Re: Clean Machine Carwash
4200 San Mateo Blvd., NE
Traffic Circulation Layout
Engineer's/Architect's Stamp **6-9-16** (G18-D049)

DRAINAGE AND TRANSPORTATION INFORMATION SHEET

Re: Traffic Circulation Layout for 4200 San Mateo Blvd
87110

A1.2

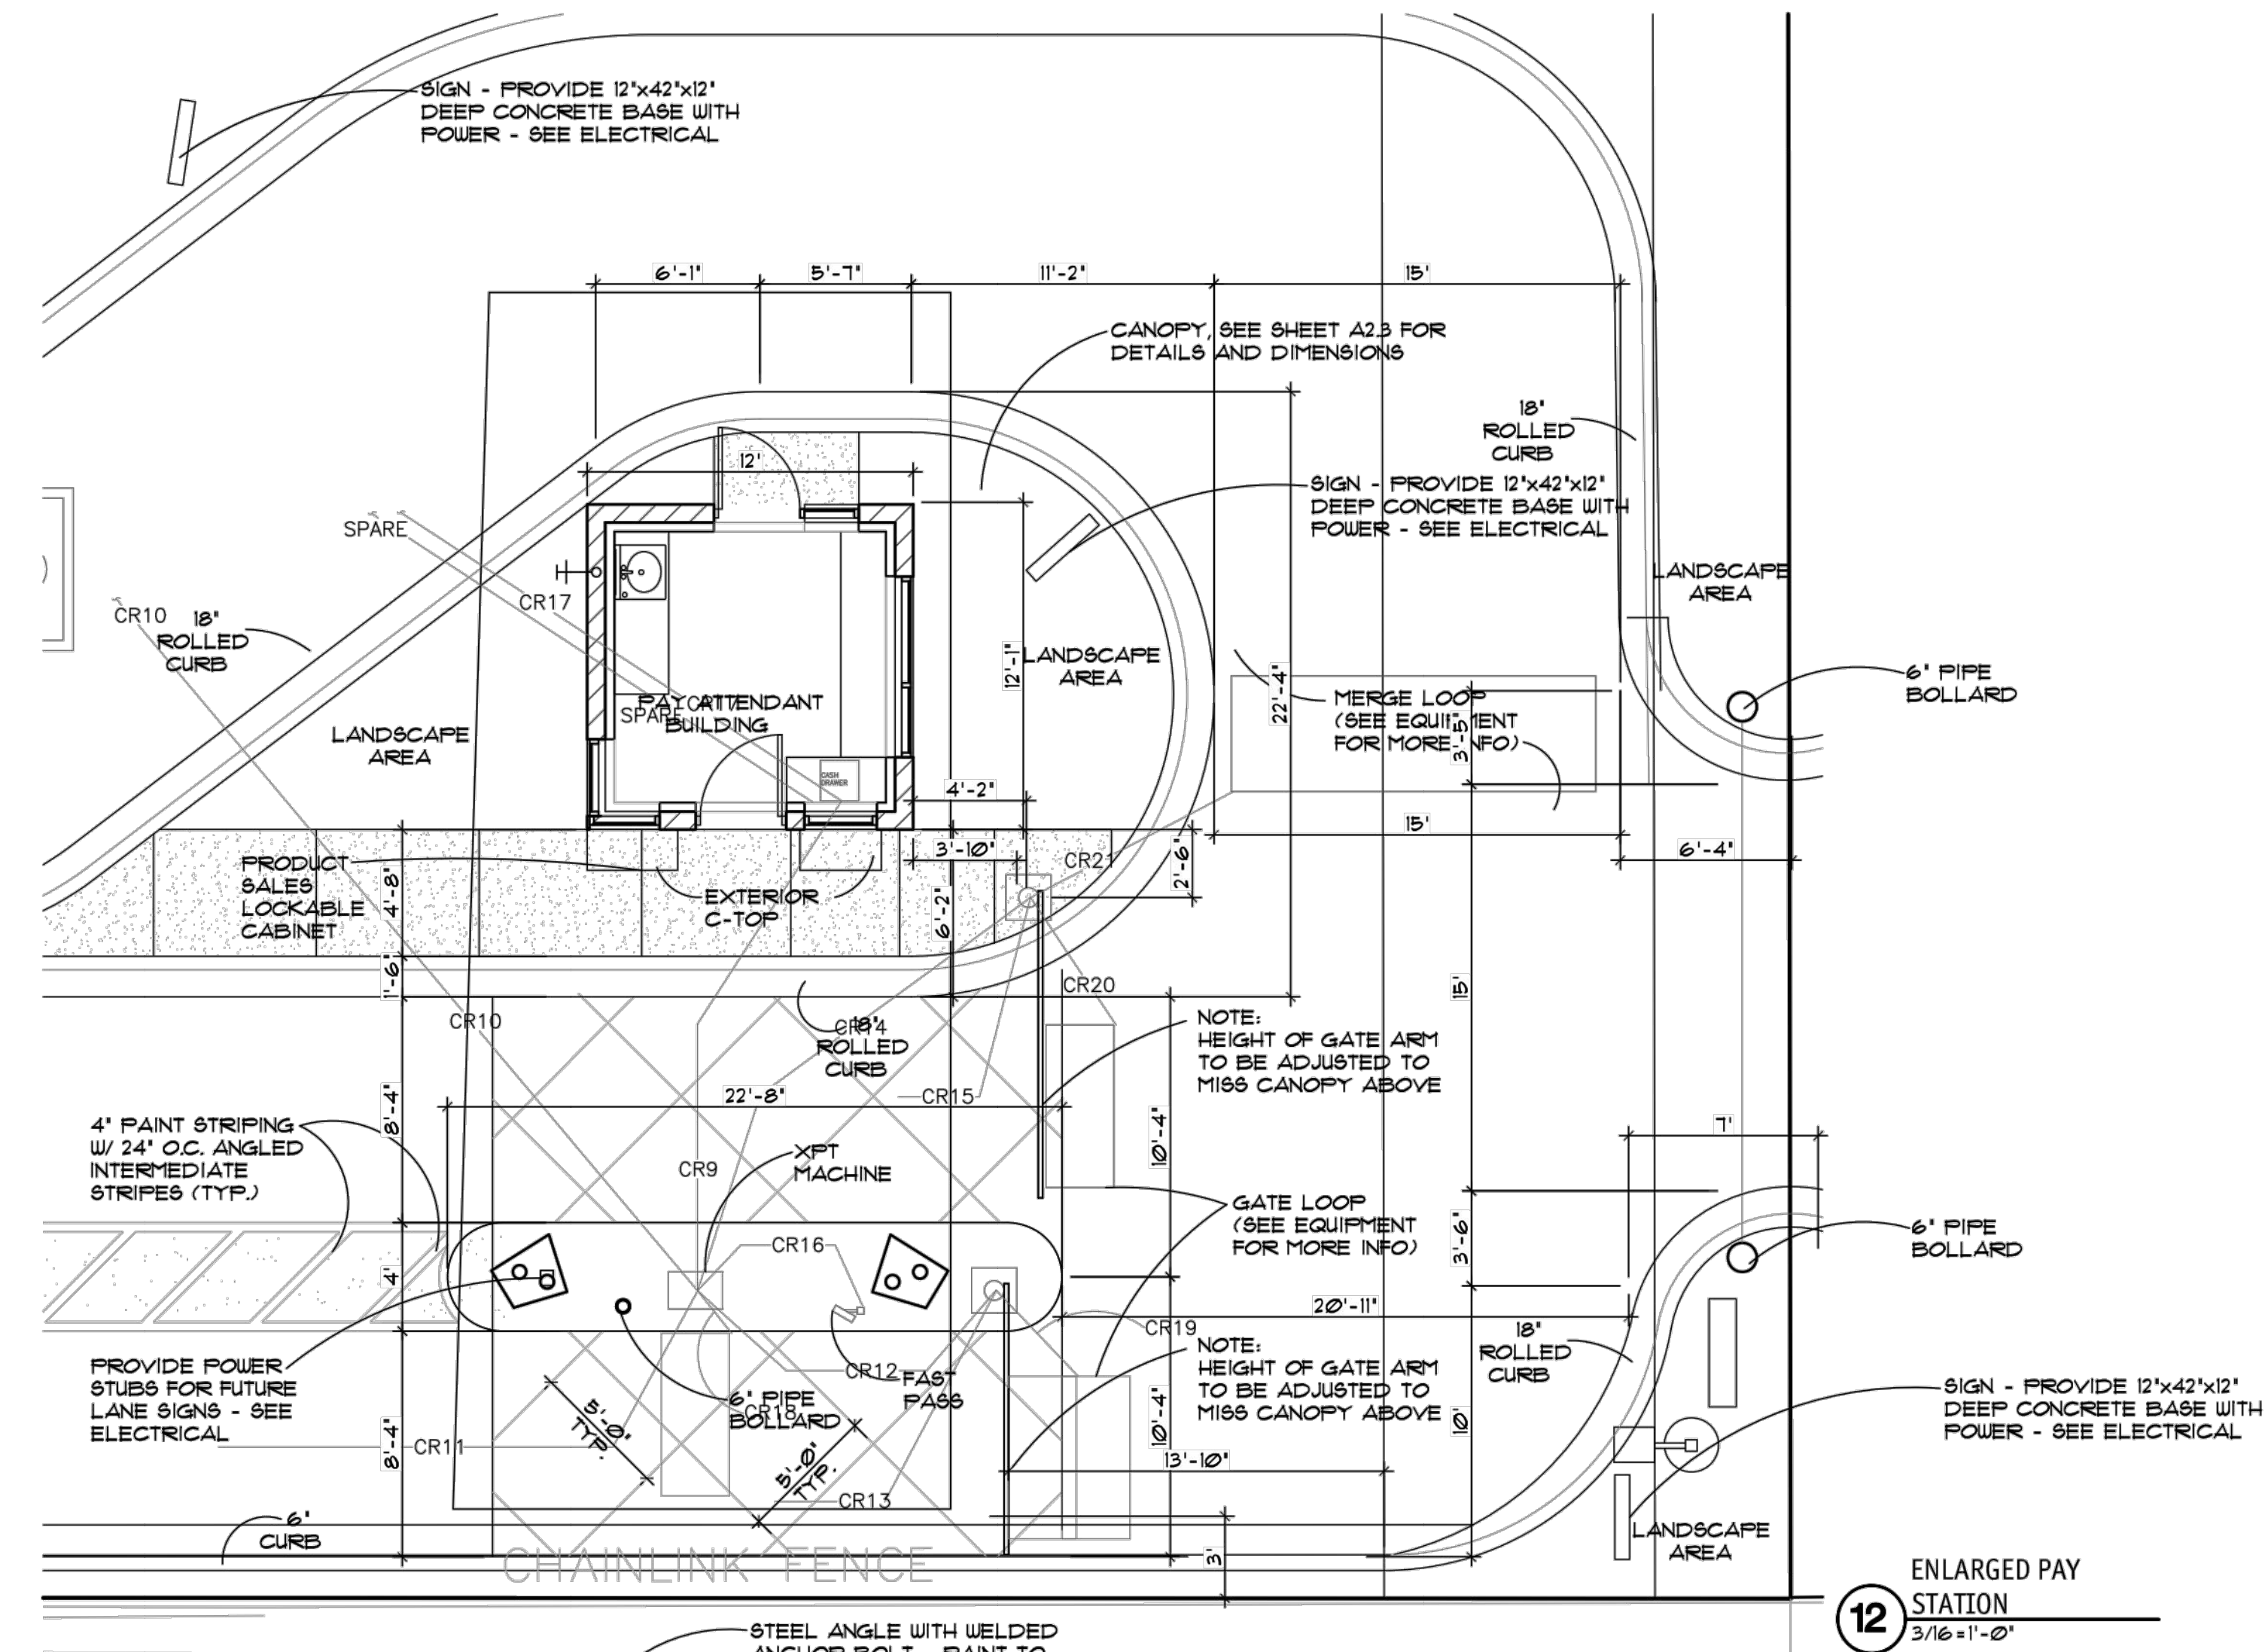
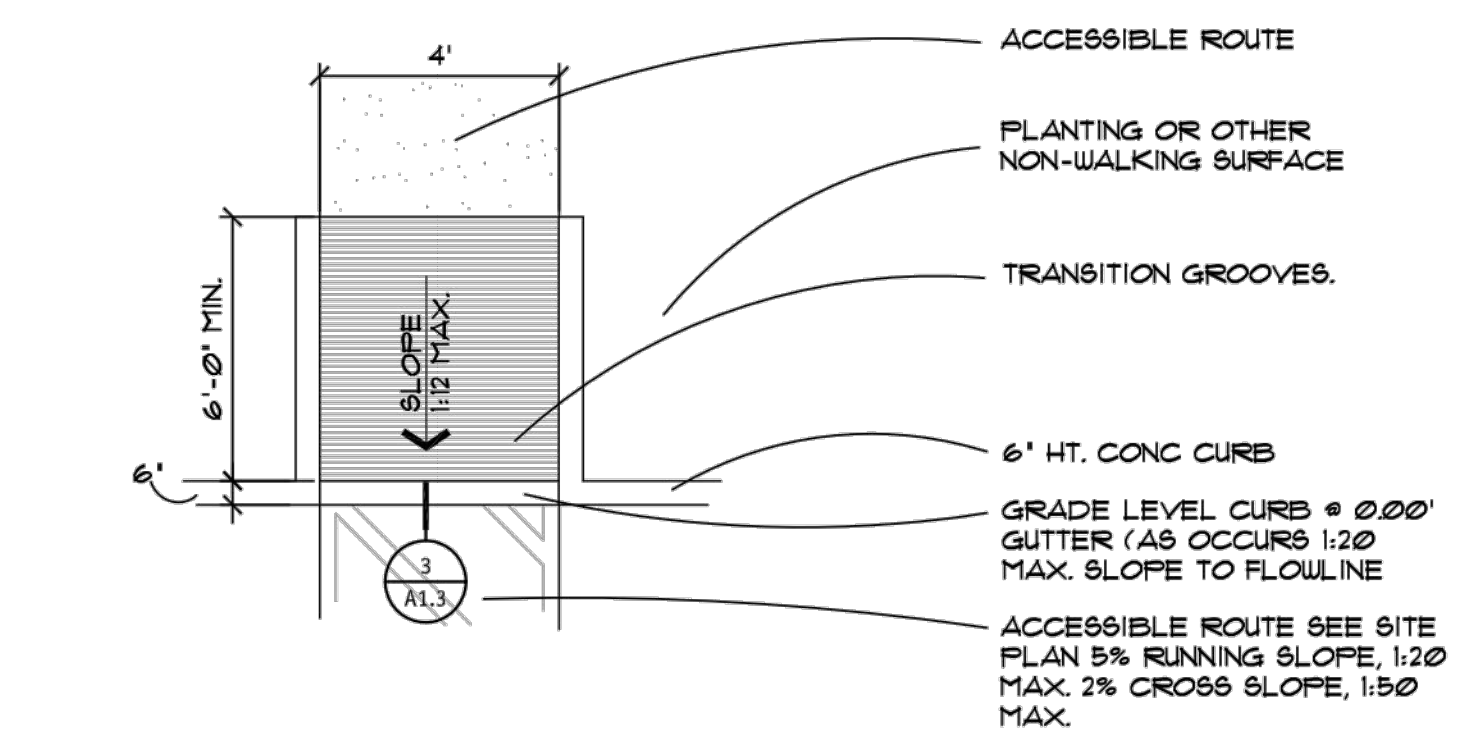
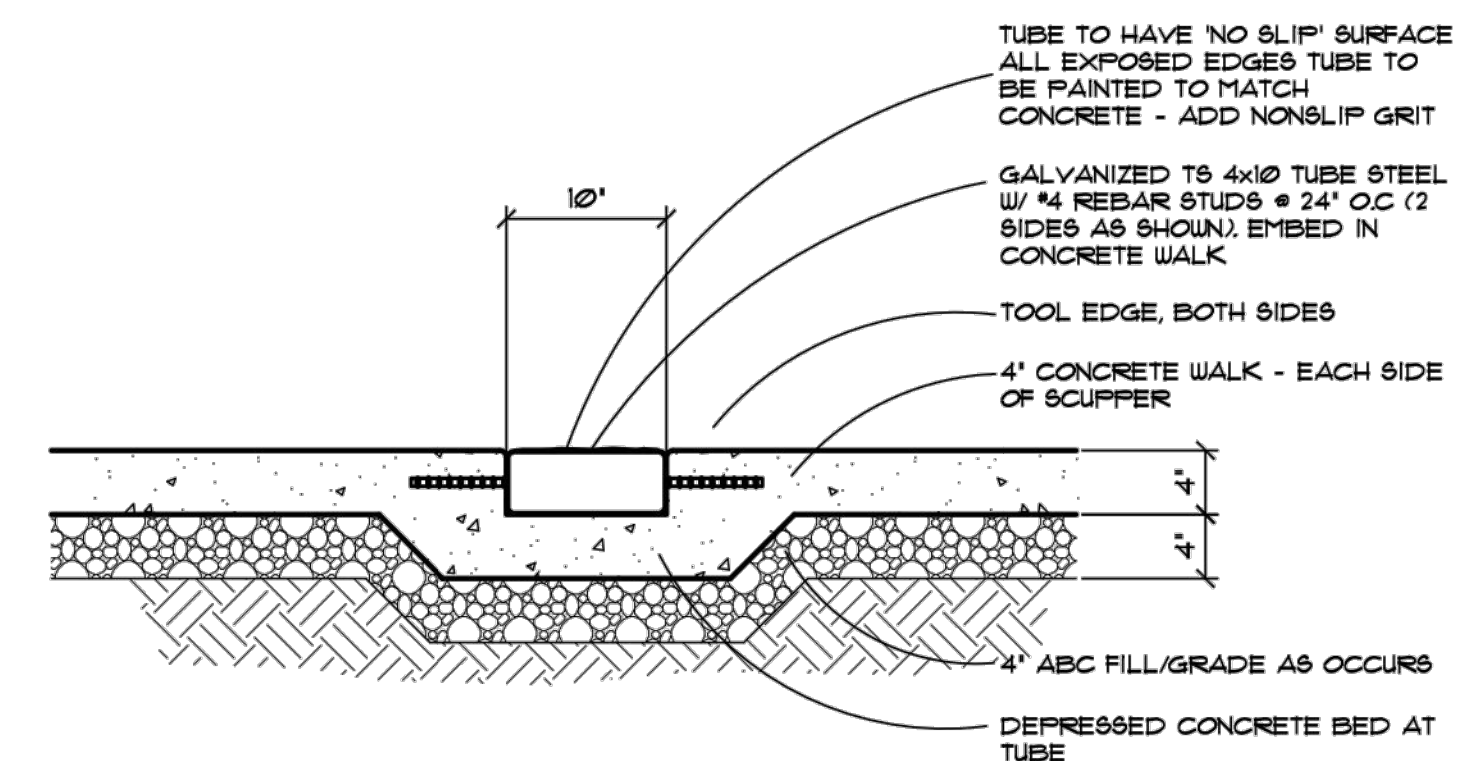
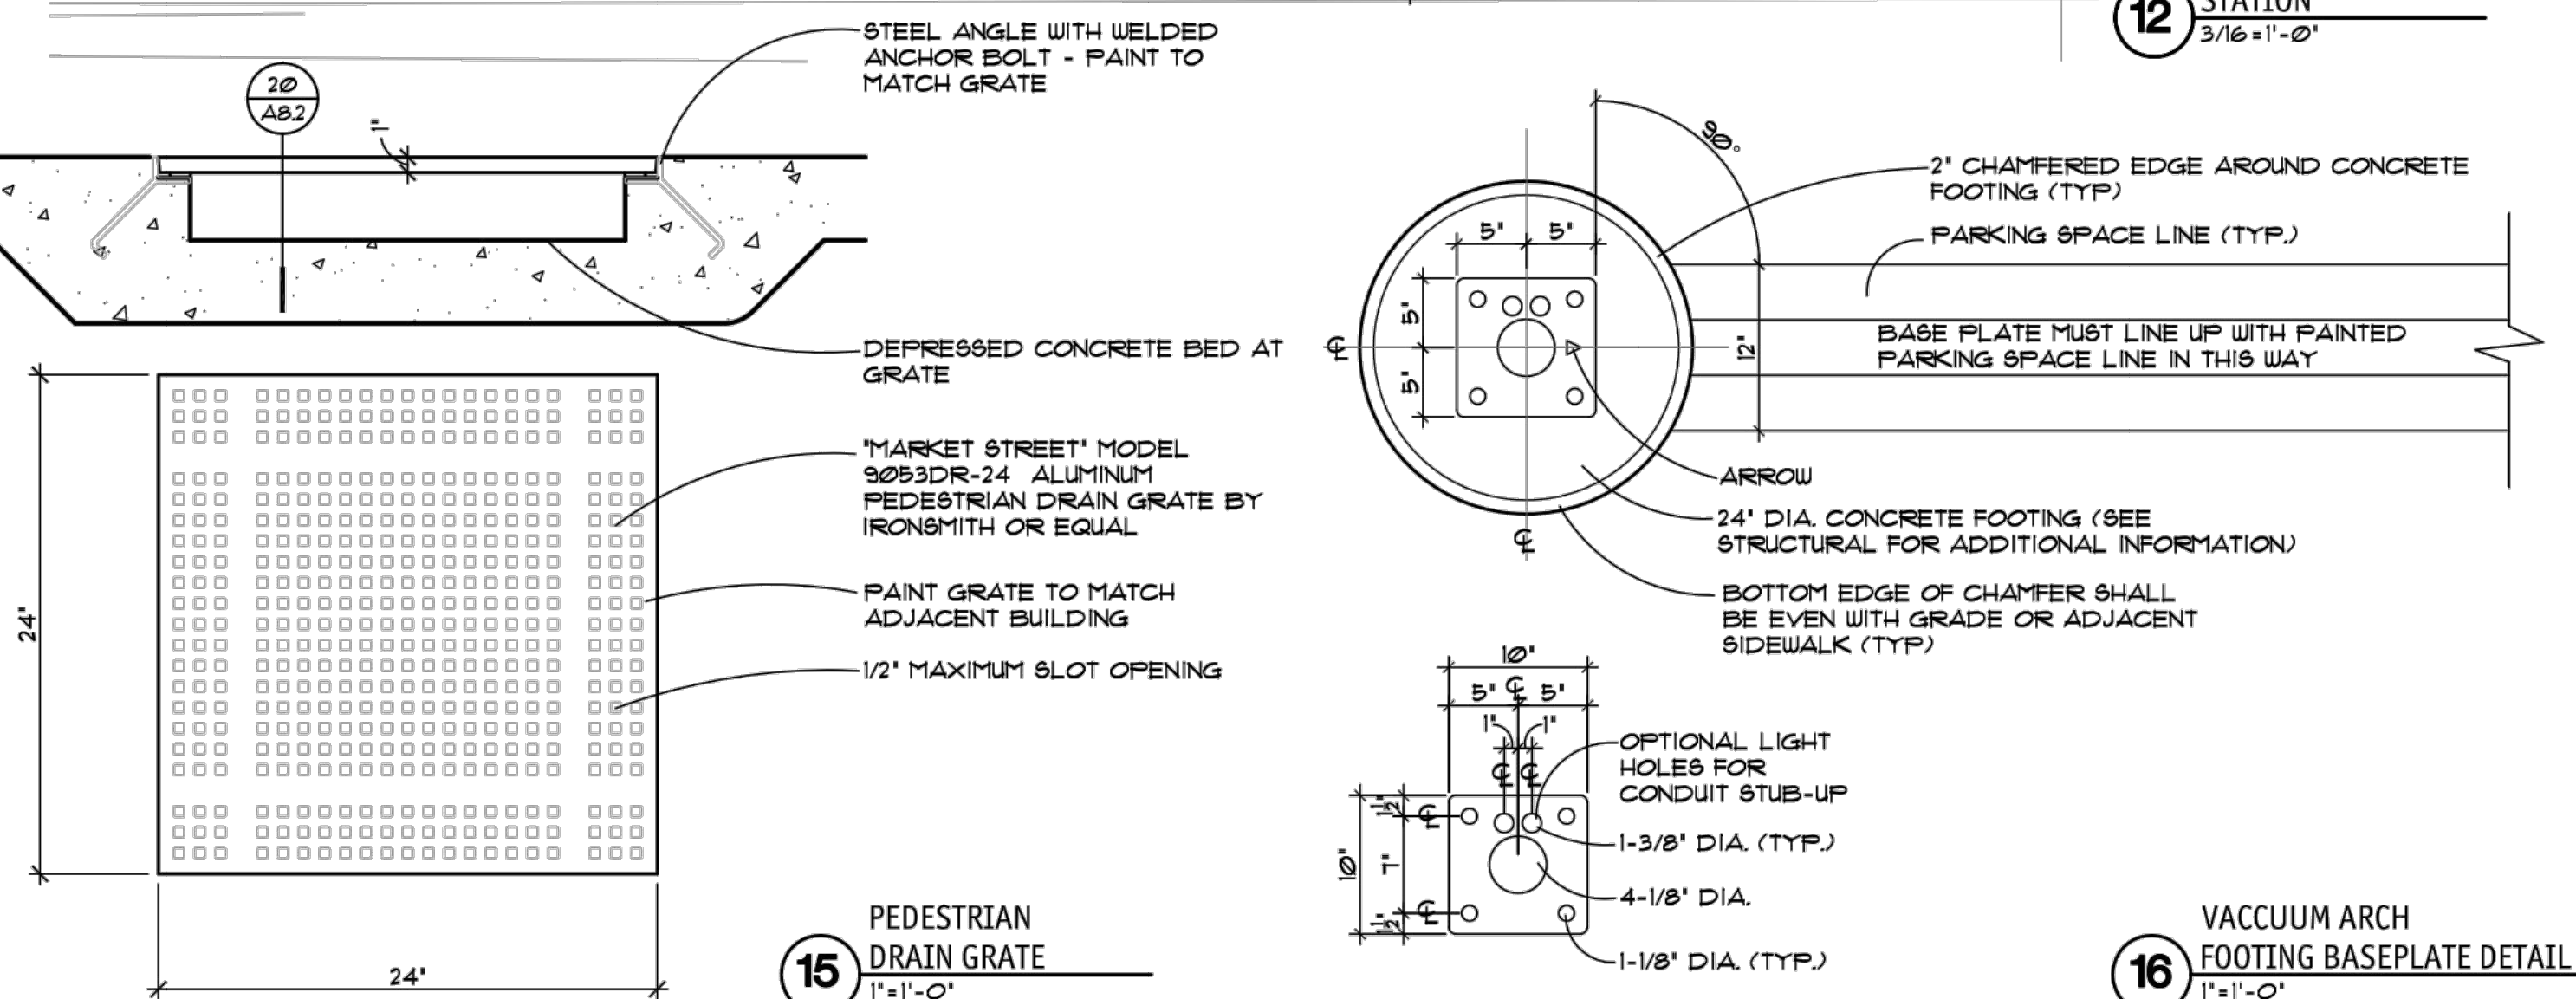
1. Clarify circulation of vehicles at the main entrance on San Mateo Blvd. There appears to be conflicting vehicle movements. Please add detail of directional arrows and signage.
2. Detail and dimension bicycle and motorcycle parking spaces, along with appropriate signage.
3. The ADA accessible parking sign must have the required language per 66-7-352.4C NMSA 1978 **"Violators Are Subject to a Fine and/or Towing."** Please call out detail and location of HC signs. See attached 2009 NM Accessible Parking Checklist page 3 of 6.
4. One-way vehicular paths require pavement directional signage and a posted **"Do Not Enter"** sign at the point of egress. Please show detail and location of posted signs.
5. Please specify the City Standard Drawing Number when applicable.
6. Please include two copies of the traffic circulation layout at the next submittal.

1. See details on Sheets A1.2 & A1.3
2. Arrows shown on Sheet A1.1
3. Curb is shown as 40' on A1.1
4. See dimension on Sheet A1.1
5. Median and ROW shown on A1.1
6. Added MC and bike rack to A1.1
7. Dimension of handicap accessible space on A1.1
8. ADA sign shown on detail 22/A1.3
9. See A1.1 for 6 ft wide ADA access
10. Curb details shown on 1&4/A1.2
11. Do Not Enter signs shown on A1.1 as Detail 24/A1.3
12. City standards called out on A1.1
13. Added note to A1.1
